1 **ADDENDUM NO. 1 (Rev 1/2023)**

2 **ISSUE DATE: October 20, 2023**

3  
4 **RE: Williams Fieldhouse Seating Renovation**  
5 **University of Wisconsin, Platteville - Athletics Department**  
6 **Platteville, Wisconsin**  
7

8  
9 Division Project No. **H-22-001**

Graphic Scale	
UWSA Number	H-22-001
MSN Number	
Set Type	BD
Date Issued	09/20/2023
Sheet Number	<b>AR101</b>

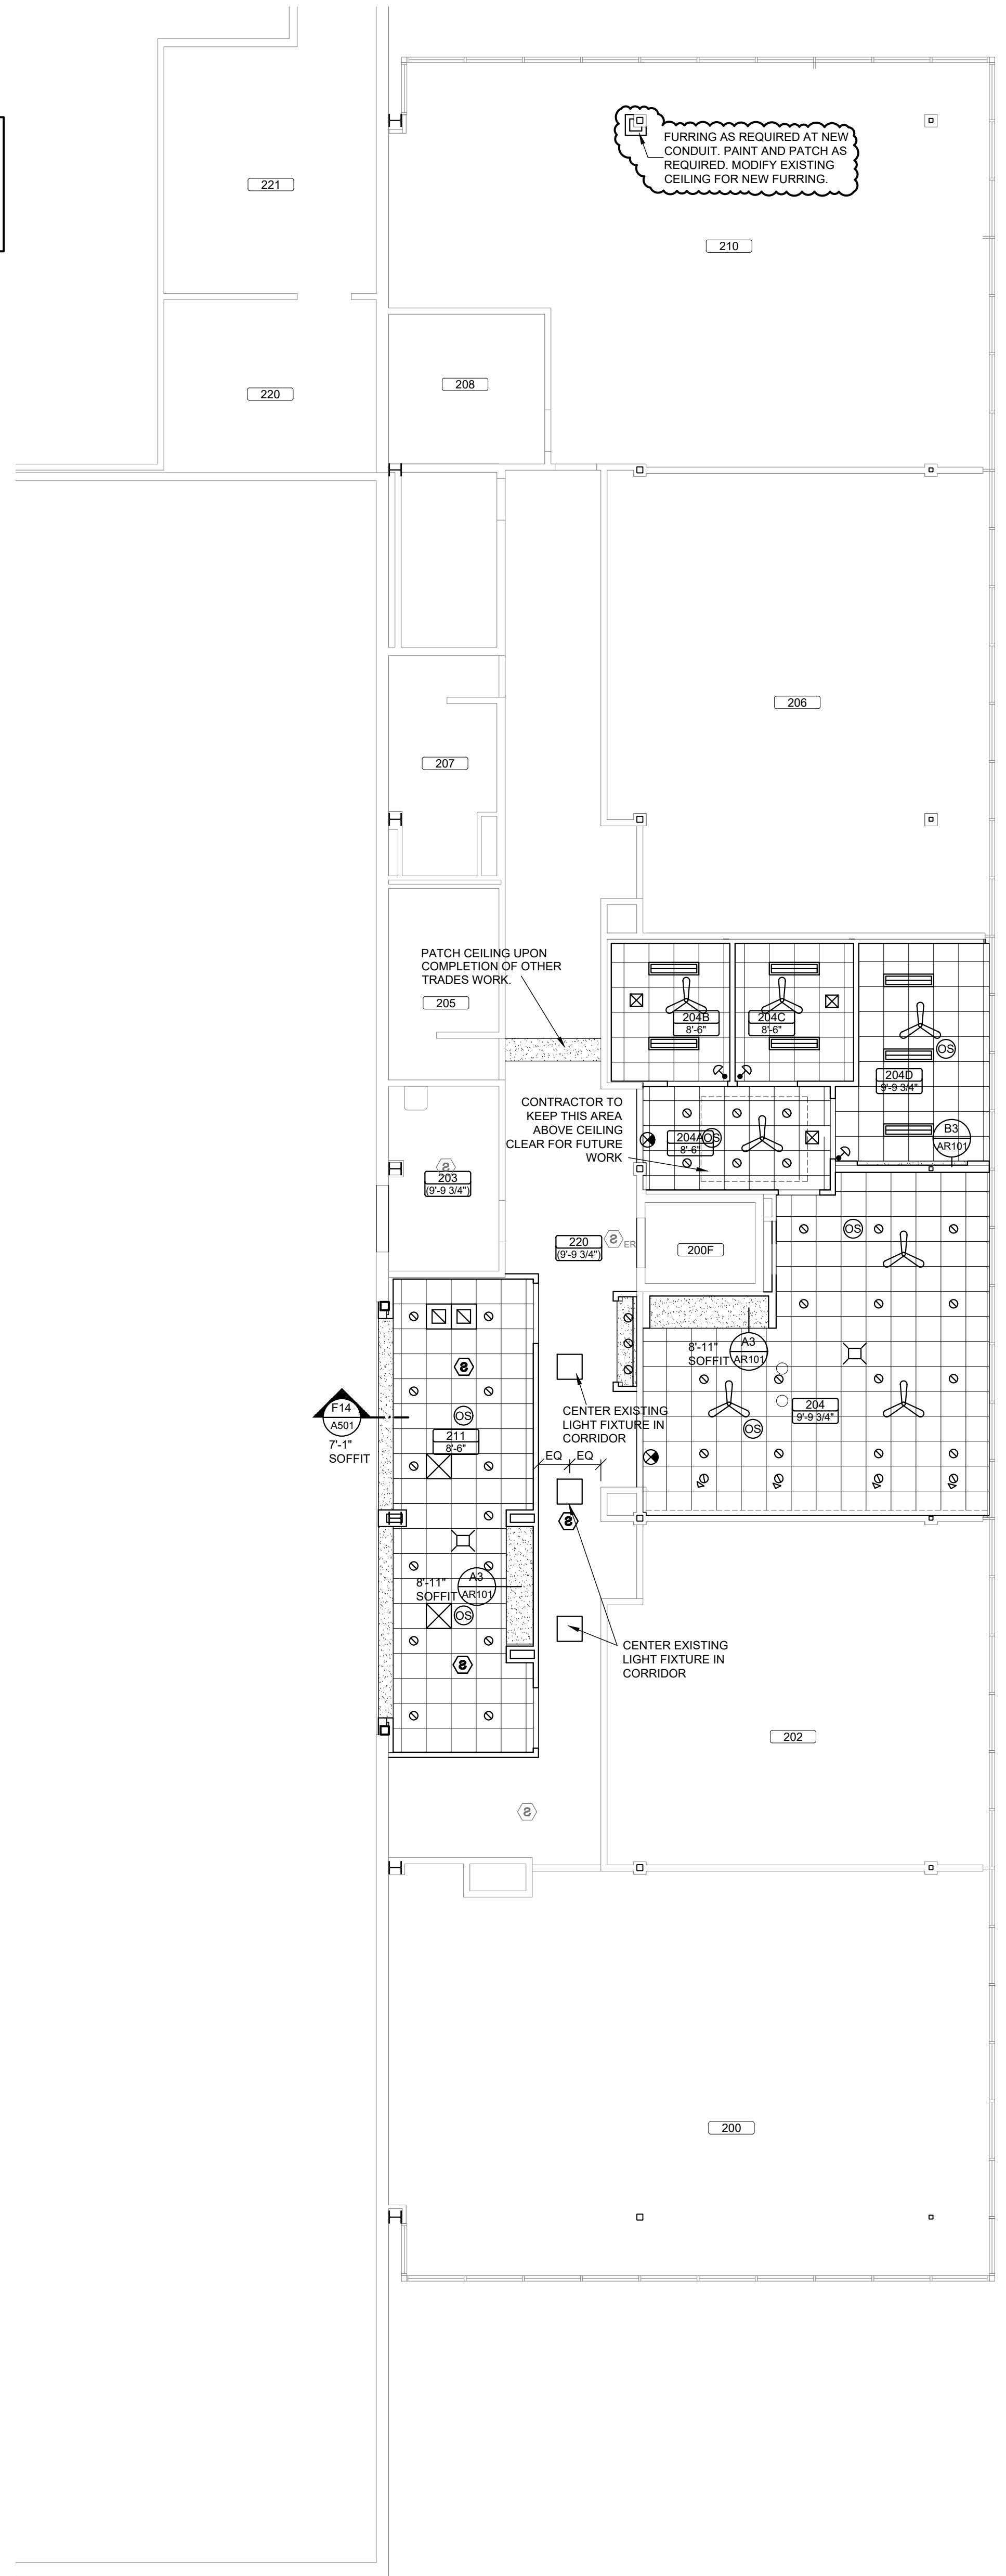
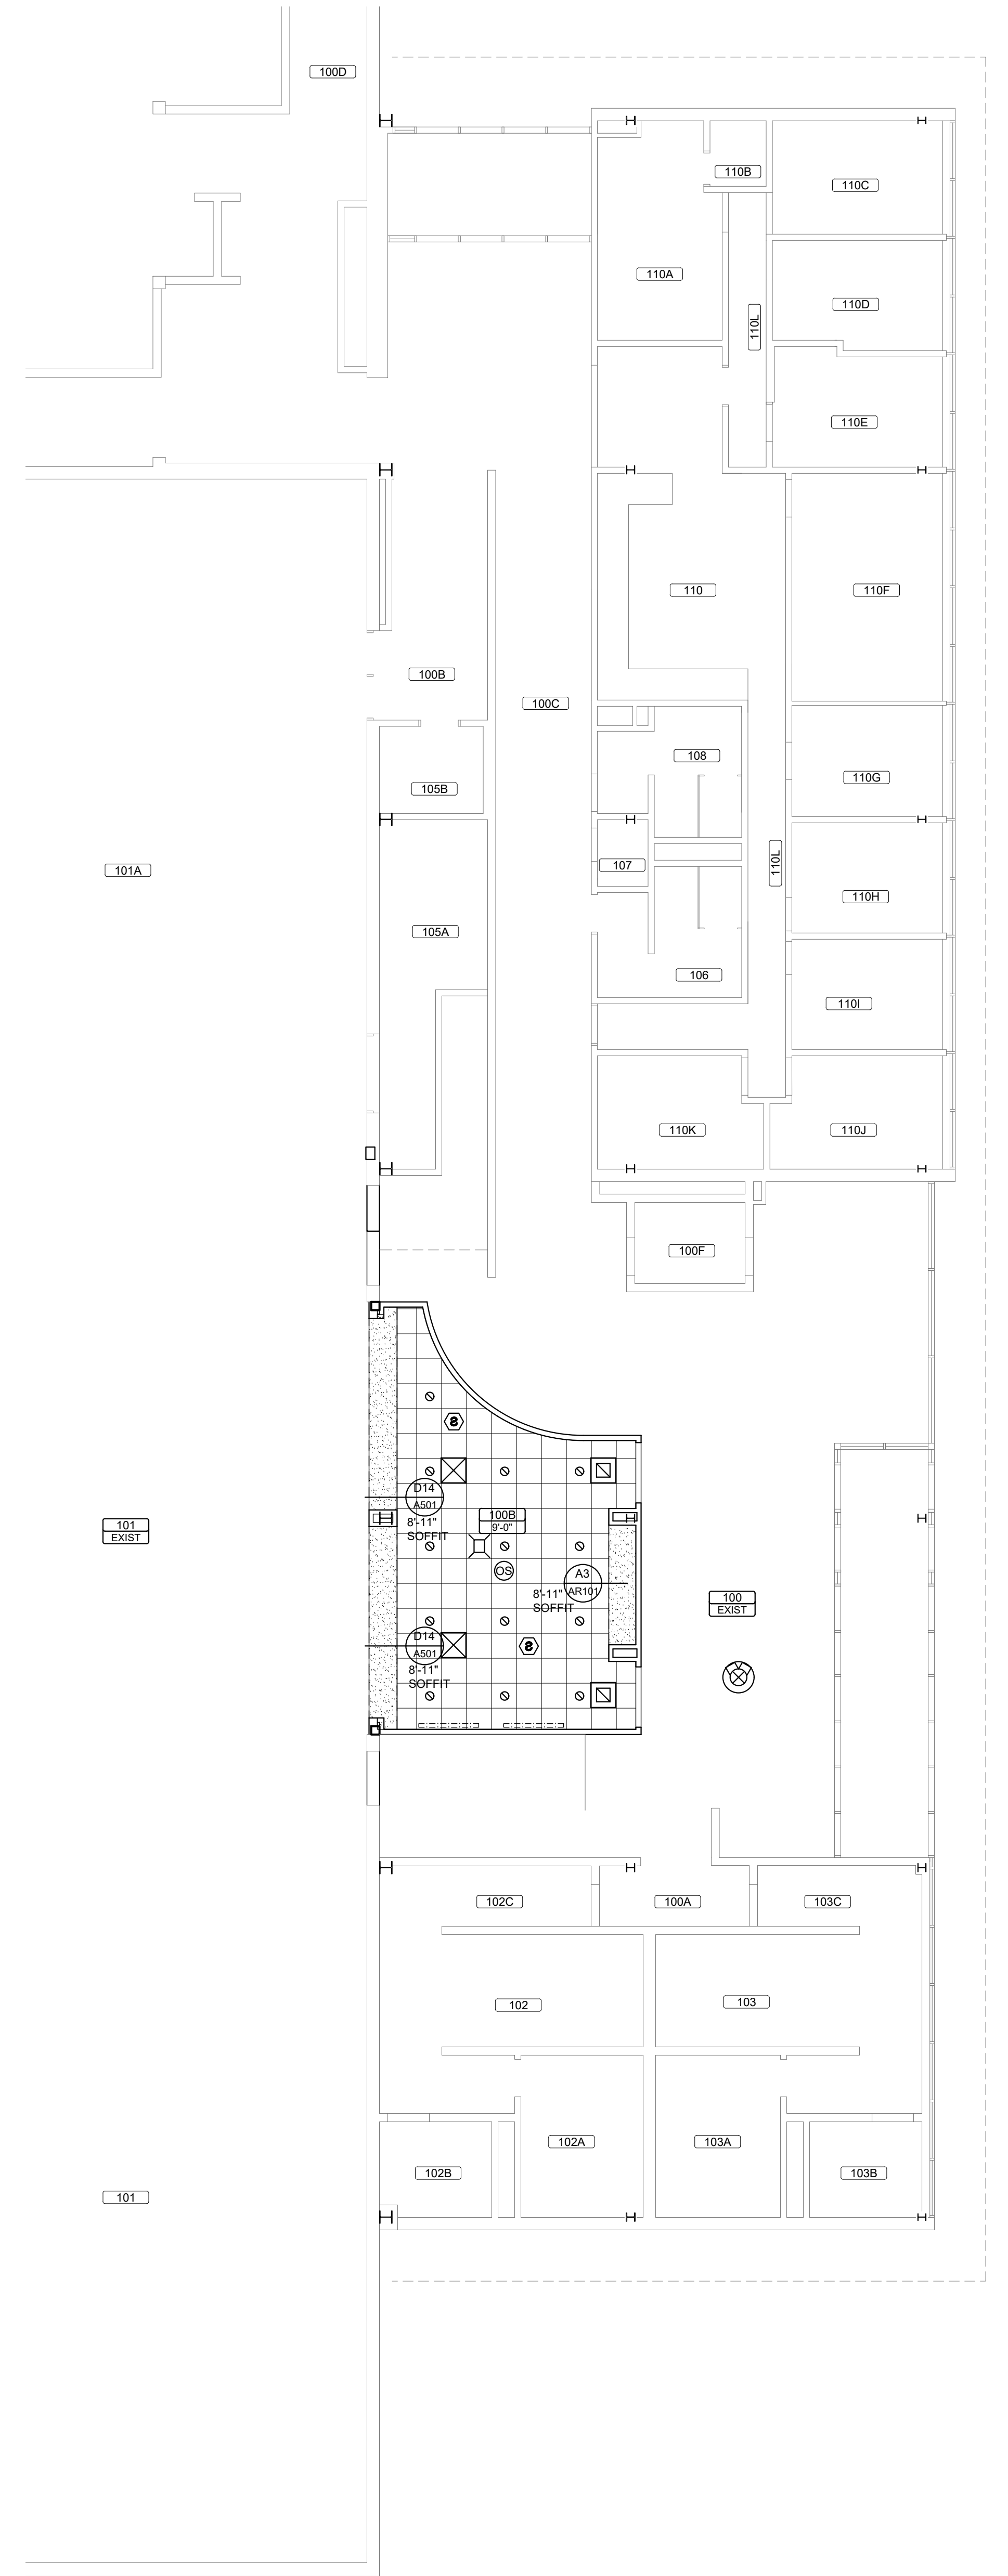
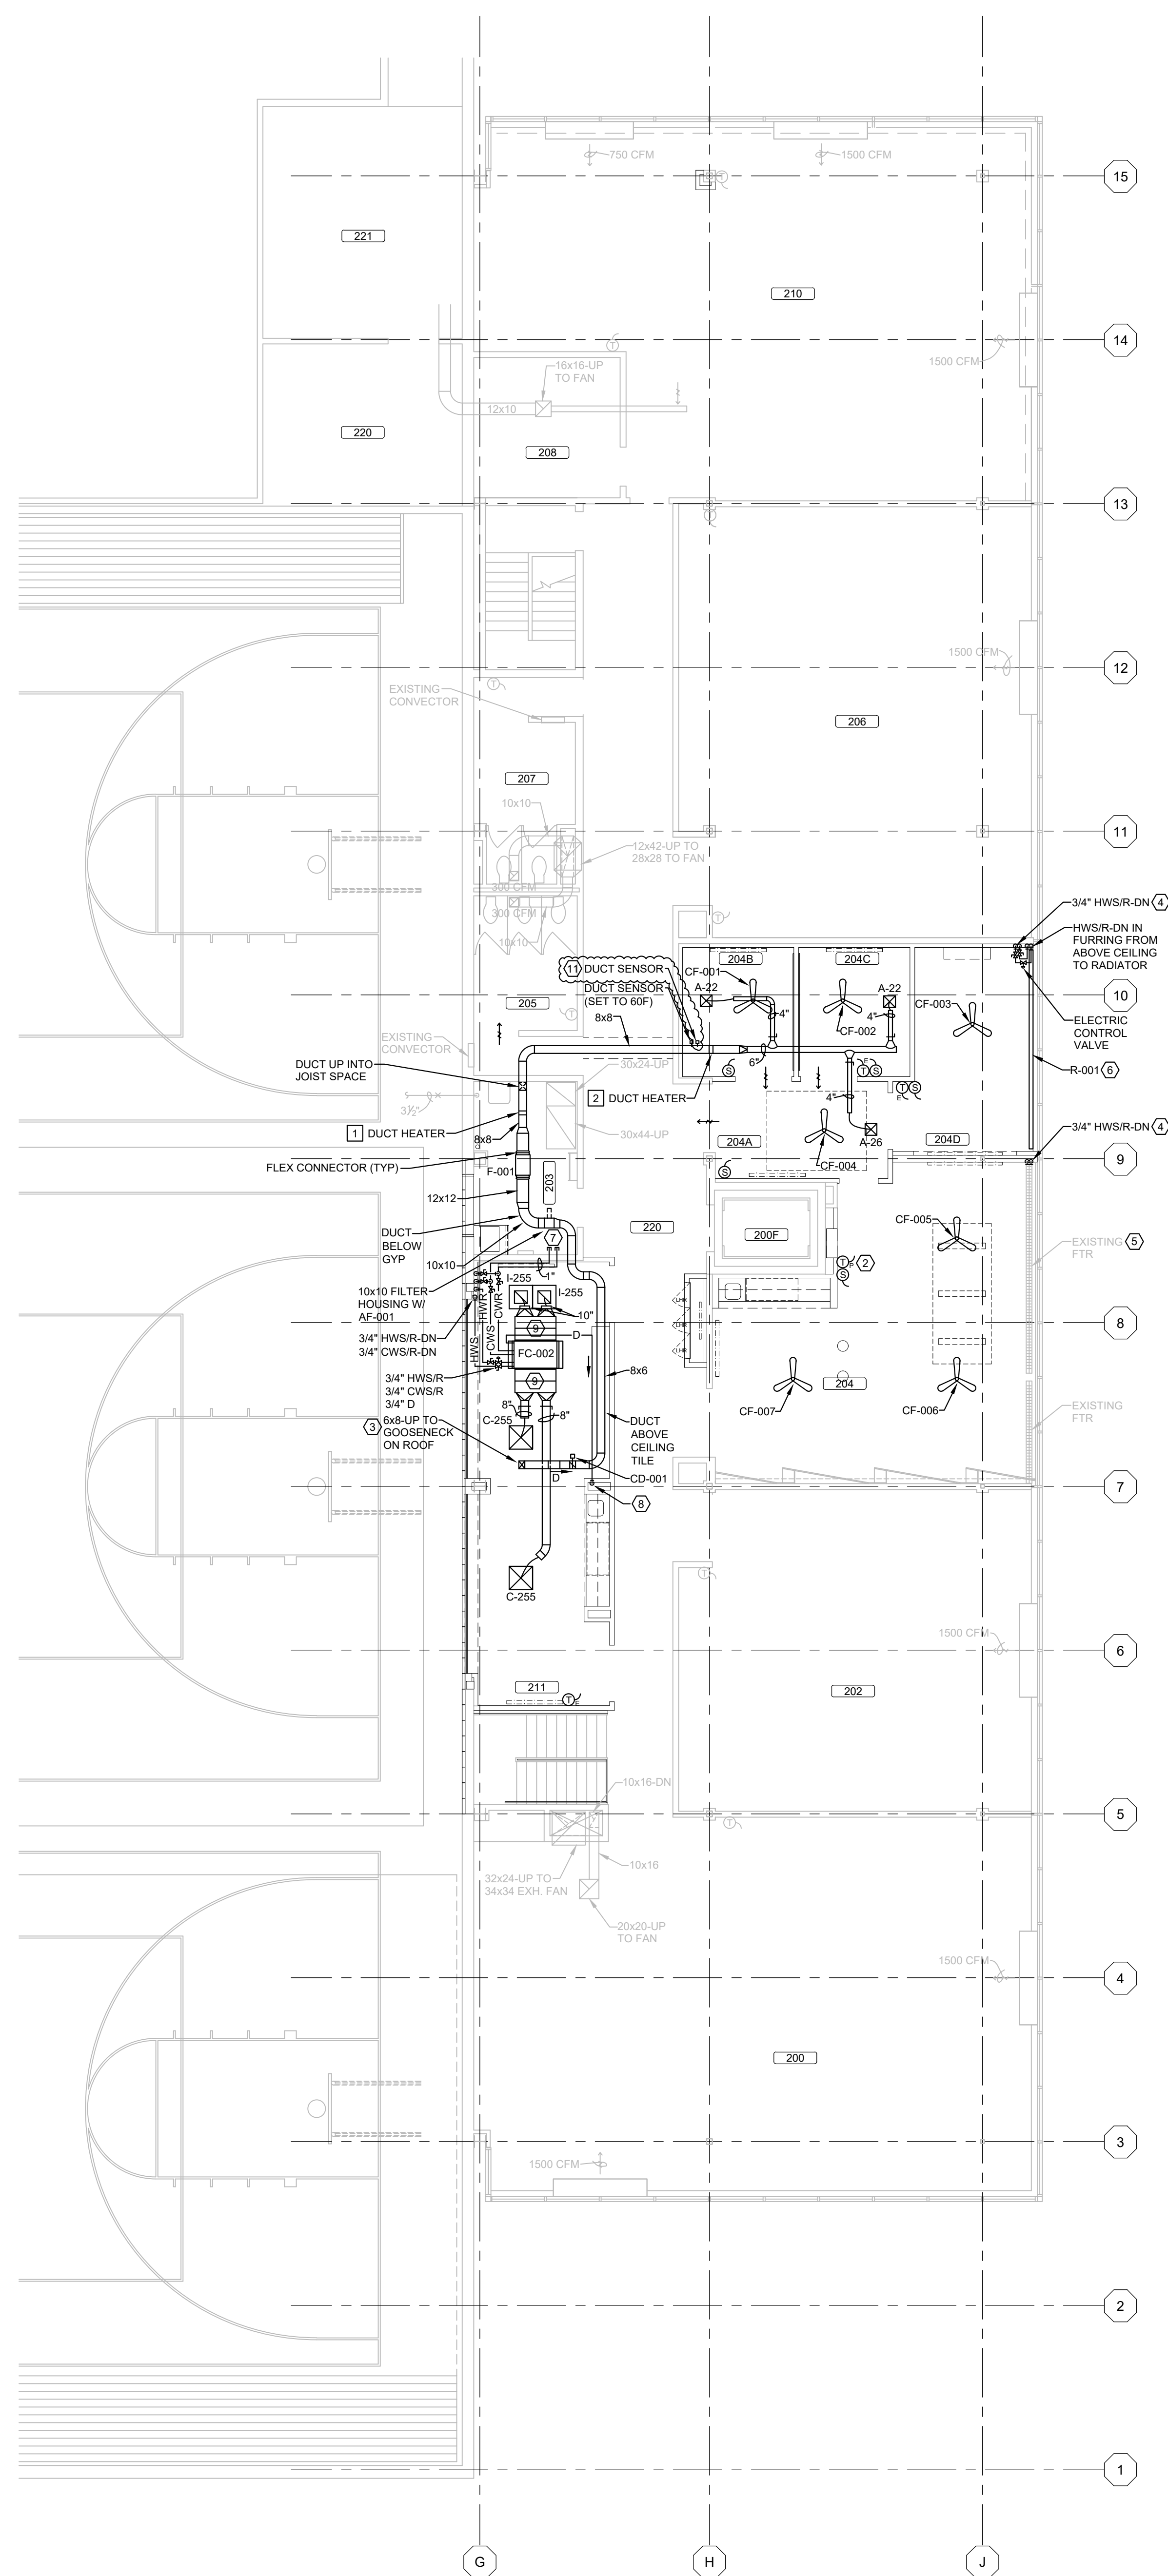
52  
53 1. Drawings A101 NEW WORK PLANS and AR101 REFLECTED CEILING PLANS

- 56  
57 1. At first floor, modifying and patching existing wall for installation of added conduit.
- 58 2. At second floor, adding furring to enclose conduit.
- 59 3. Added clarification of furring type on second floor.
